RFI#: 14 Date: 12/14/2011 Job: EB-02 Keller Springs Lofts Phone: 877-777-5115

Subject: Drinking fountain

RFI #: 51 Date: 2/7/2012 Job: EB-02 Keller Springs Lofts Phone: 877-777-5115

Subject: Pool and fountain equipment drain requirements

Drawing: L5C

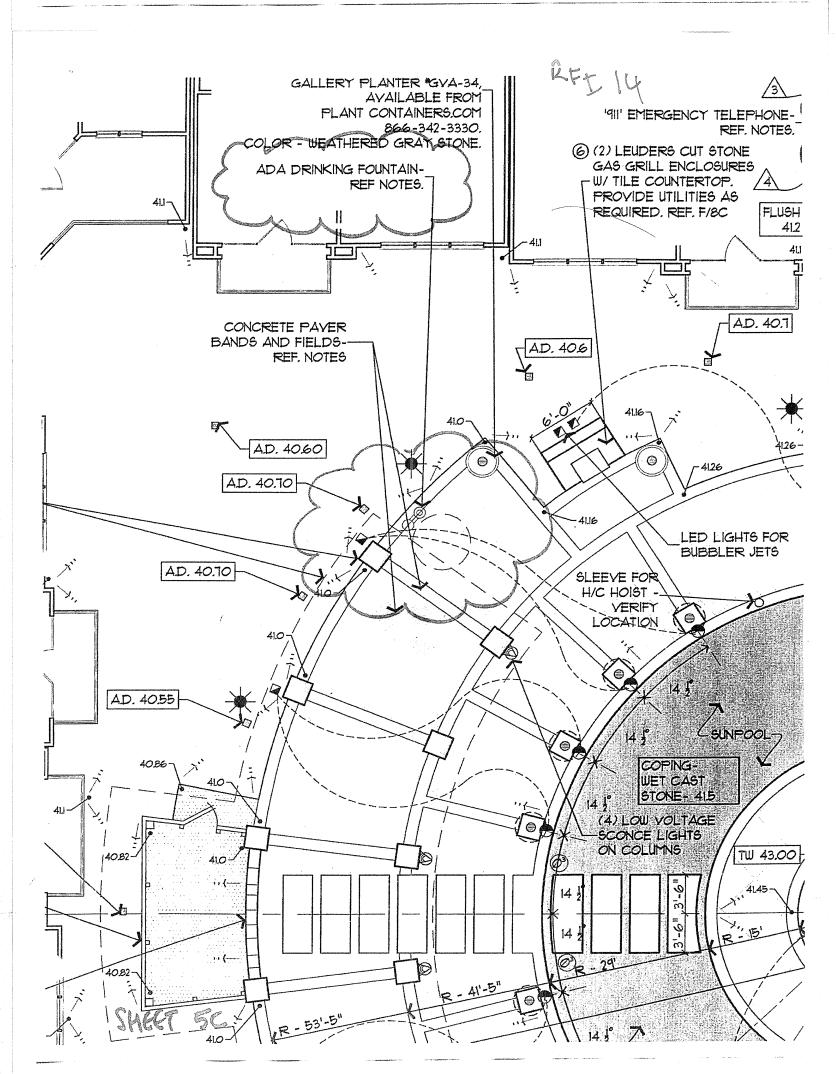
Cost Impact: None Schedule Impact: None Date Required: 12/21/2011 Please verfiy that there is a drinking fountain in the swimming pool courtyard. If there is please provide location Requested by: Bryan Pickler Embrey Partners, Ltd. THERE IS A DRINKING FOUNTAIN SPECIFICO FOR THE POOL COURTYARD. REFERENCE SHOWN JUST NORTH OF THE CURVED TREUIS ON THE EDGE OF THE POOL DECK. THE MODEL NUMBER, COLOR AND MANUFACTURER ARE NOTED ON THE MATERIAL COLORS ON THE RIGHT HAND SIDE OF SHEET TO. DIGHTATUR BR.

Page 1 of 1	
	RFI #51	
- 6"W SERVING POOL EQUIPMENT CAUIPMENT (BACKFLOW PREVENTER & YARD BOX BY OTHERS.)	REFERENCE DWG: SCALE: P-3.0C, P-3.0E DATE: 02-16-2012 REVISION: RFI #51	SK-P1
ALT. G	KELLER SPRINGS LOFTS	ADDISON, TX
6"

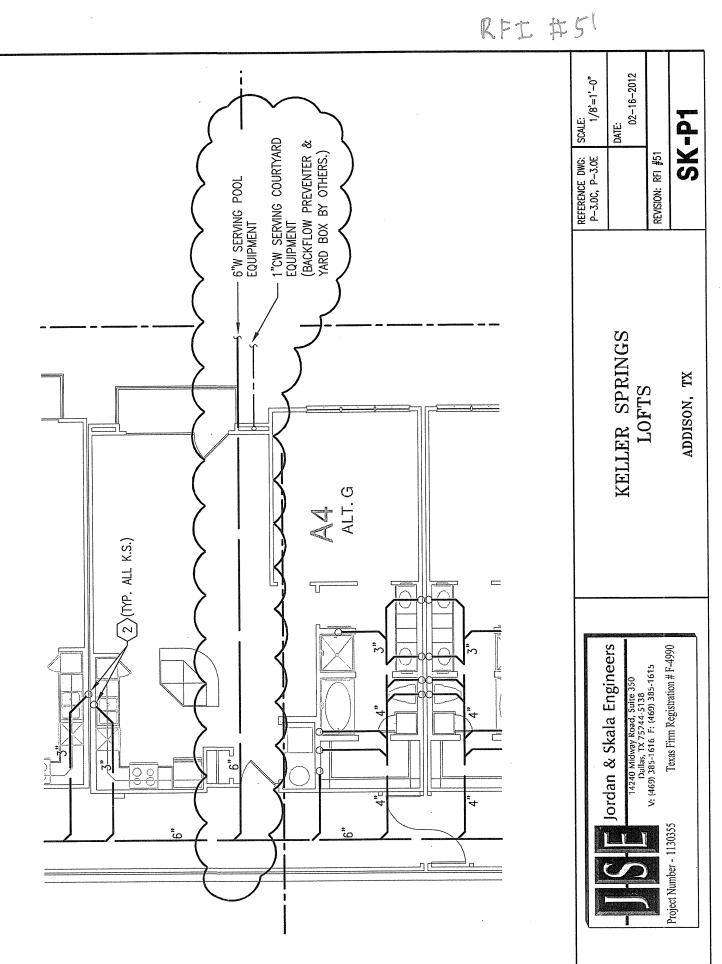
Schedule Impact: None Request: Date Required: 2/14/2012 Jordan and Skala, In discussing the courtyards fountain and pool equipment requirements with our pool contractor, it has come to our attention that since the pool equipment will have a chlorinated filter system, by code, we are required to run that into the sanitary sewer. The fact that the fountain equipment is run with a non-chlorinated system, the pool contractor believes that the fountain equipment can be run into the existing storm sewer system in the fountain courtyard. Therefore we need Jordan and Skala to revise the plans accordingly.

Please reference landscape sheet 5C of 9 for pool equipment location. Requested by: Bryan Pickler Embrey Partners, Ltd.

A 6" sanitary waste line has been routed to pool equipment area for pool drainage. See attached sketch. Russell Cox Answered by
